**SUBJECT:** 2013 CX-5 - Steering Wheel Core Cover Concern

Special Service Program (SSPA4)

# 2013 CX-5 - Steering Wheel Core Cover Concern Special Service Program (SSP) A4

#### C. REPAIR PROCEDURE

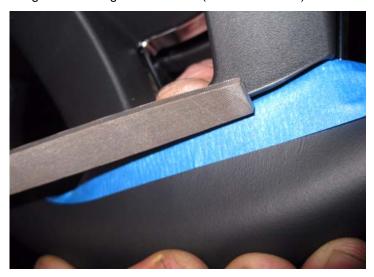
Using an emery board or file, gently file off any flashing that is found on the back-side, bottom edge of the steering wheel core cover (as shown below).

**CAUTION:** Use care not to scratch the other parts close to the back of the steering wheel.

- 1. Turn the steering wheel to the right to better access the repair area.
  - **CAUTION:** To prevent scratching, apply masking tape to the back-side of steering wheel (as shown below).
- 2. Pull on the steering wheel core cover by hand to create a small clearance between the cover and the back of the steering wheel.
- 3. Carefully file off all flashing from the edge of the cover (as shown below).

- 4. Lightly run your finger over the edge of the cover. If the surface still feels rough, continue filing until it is completely gone (smooth).
- 5. Push the steering wheel core cover back to eliminate the clearance between the cover and the steering wheel.
- 6. Remove the masking tape.
- 7. Wipe the area clean with a clean shop rag and vacuum up the filings from the seat and floor.
